CWE 2210373.03r

Subject: Revised Response to DSD-Geology Review Comments, Project Issues Report 1099348, Proposed Single-Family Residence, APN 346-831-44, Ruelle Nicole, La Jolla, California

References: 1) City of San Diego, DSD Geology Review Comments, Project Issues Report 1099348, dated October 11, 2023.
2) Sebastian Mariscal Studio, Architectural Plans, Hermann House, 2538 Ruelle Nicole, La Jolla, CA 92037, dated August 8, 2023.
3) K&S Engineering, Inc., Conceptual Grading and BMP Plans, Hermann House, Lot 25 Montoro, undated.
4) Christian Wheeler Engineering, Report of Preliminary Geotechnical Investigation, CWE 2210373.02, April 17, 2023.

Geologic Cross Section A-A'

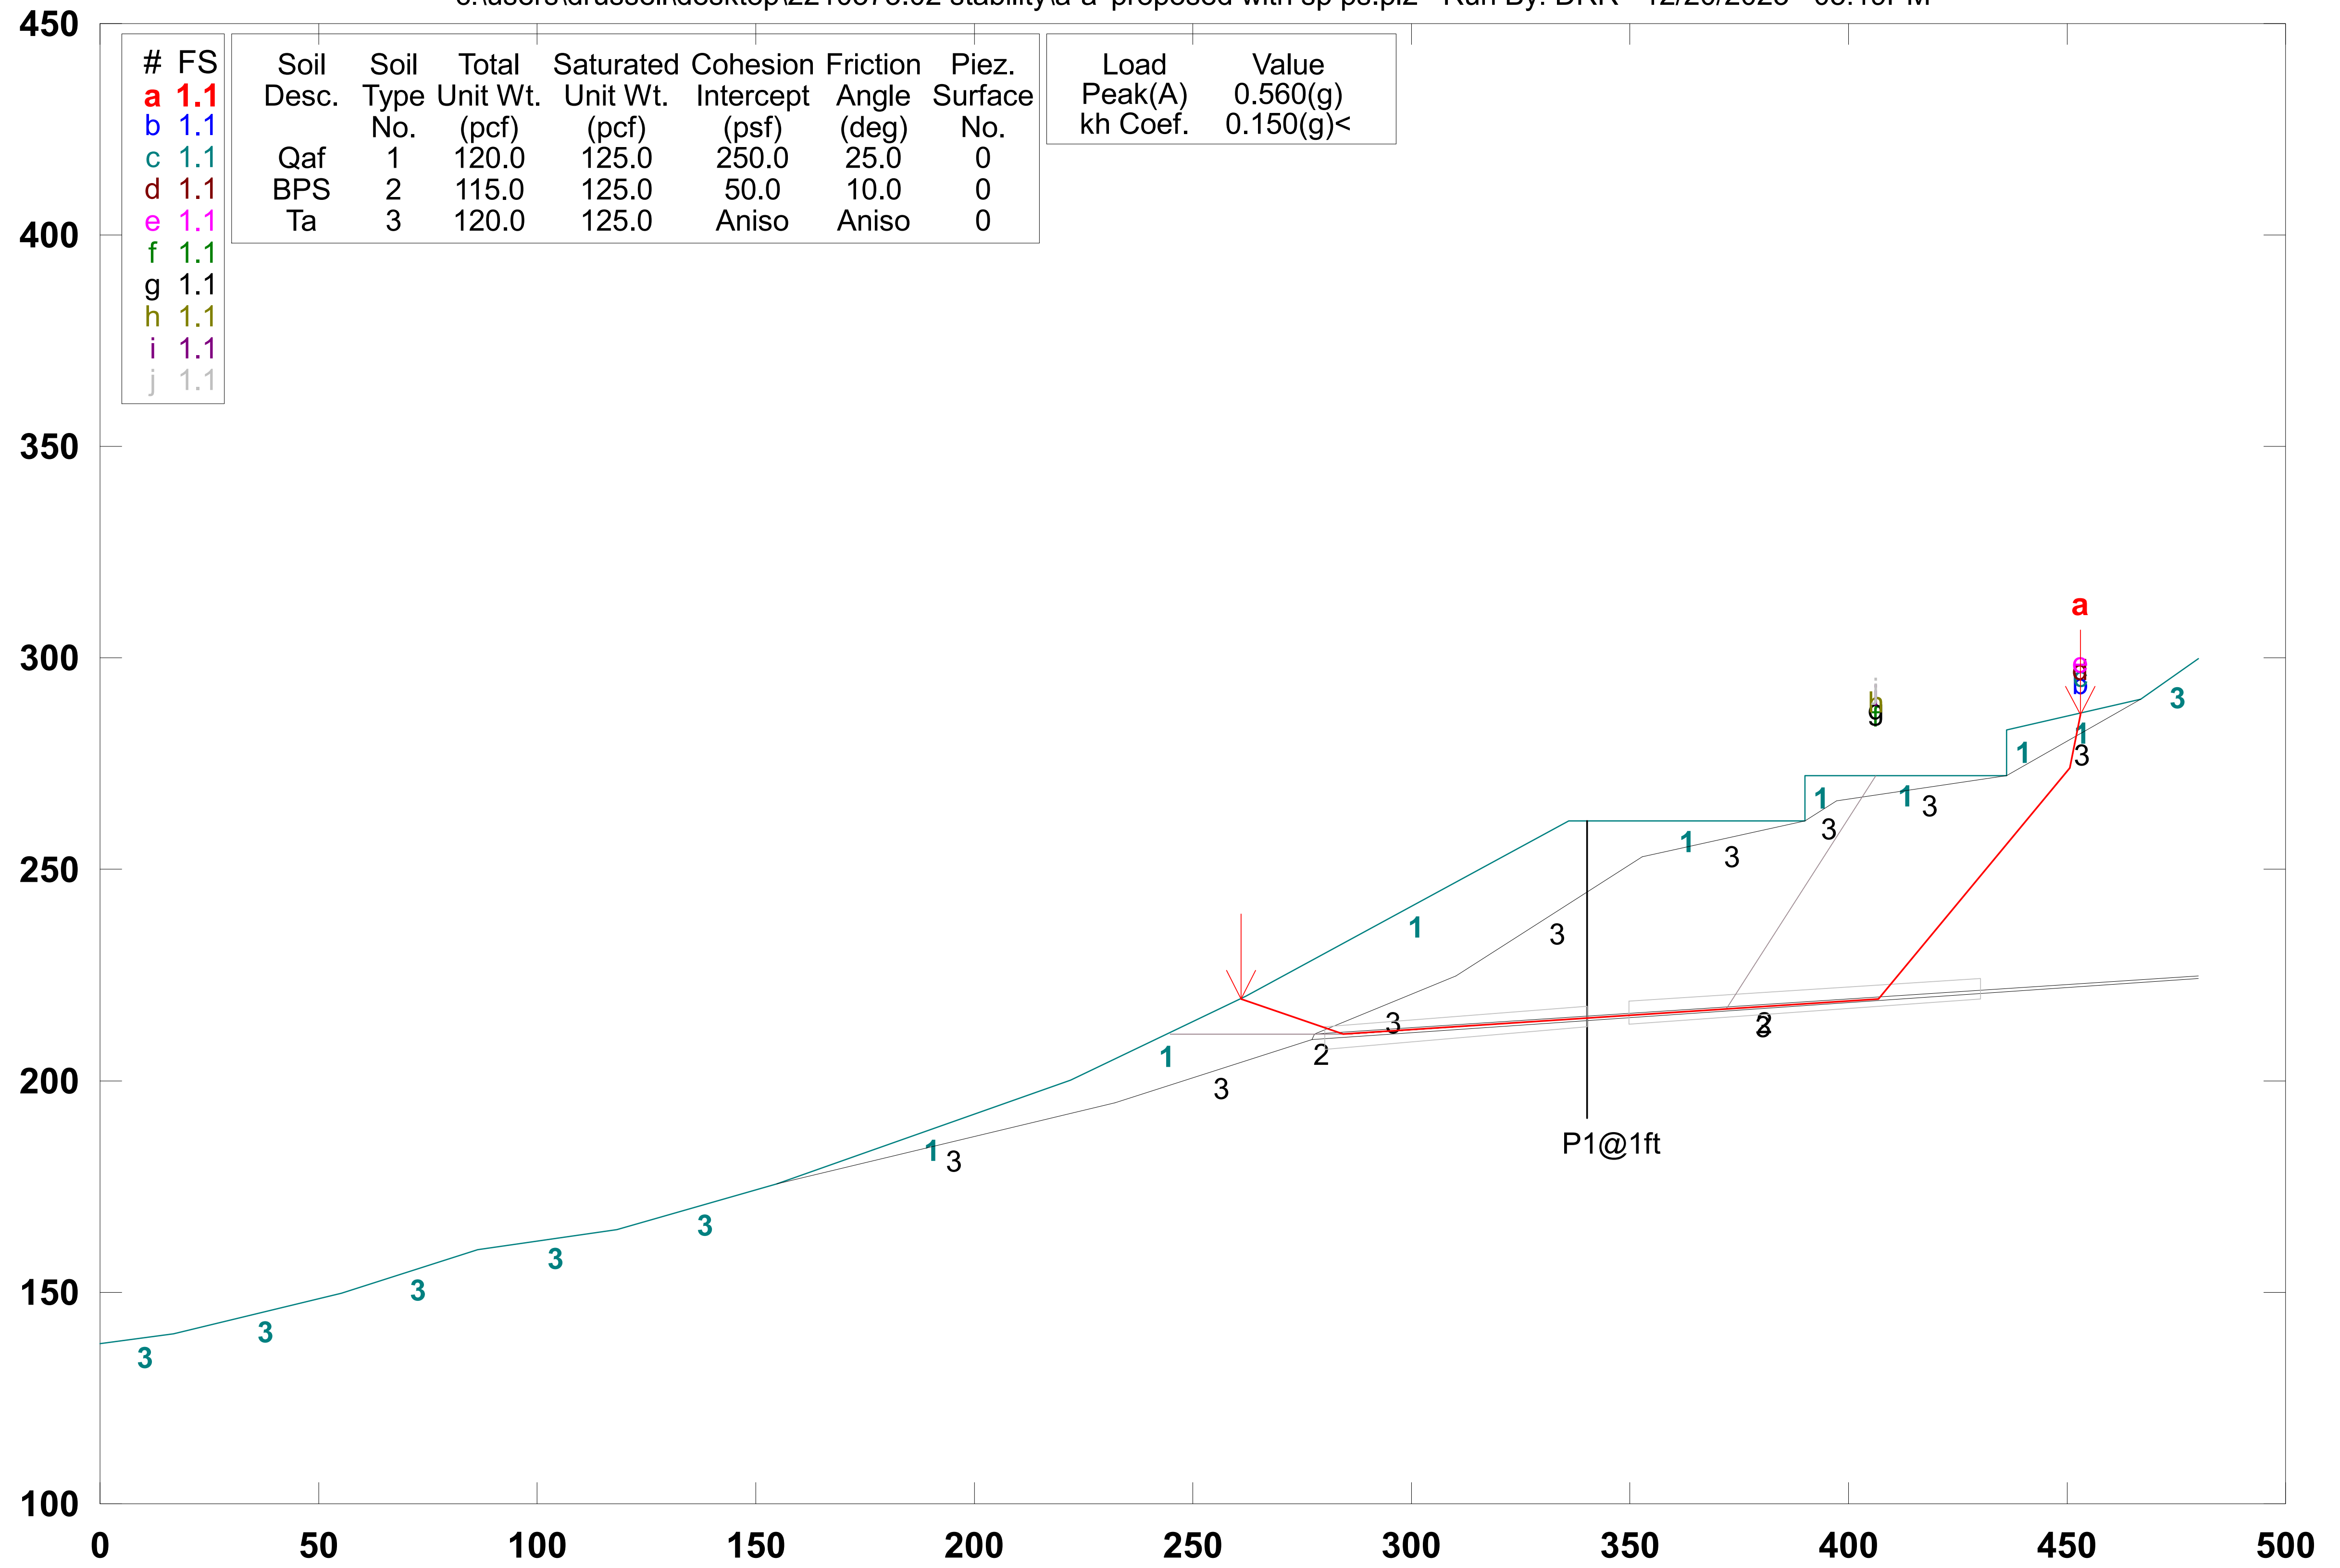
City Comment 00025: Seismic (pseudo static) slope stability is not discussed in the geotechnical report. Please provide slope stability analysis.

CWE Response: Appendix B of this report presents the results of our pseudo-static stability analysis of the proposed site topography along geologic cross section A-A' (see Plate No. 2). The results of this analysis indicate that following the proposed construction, including recommended shear pin installation, the slope that descends to the northwest of proposed improvements will demonstrate a minimum factor-of-safety against pseudo-static failure of 1.1, which is the minimum that is generally considered to be stable.
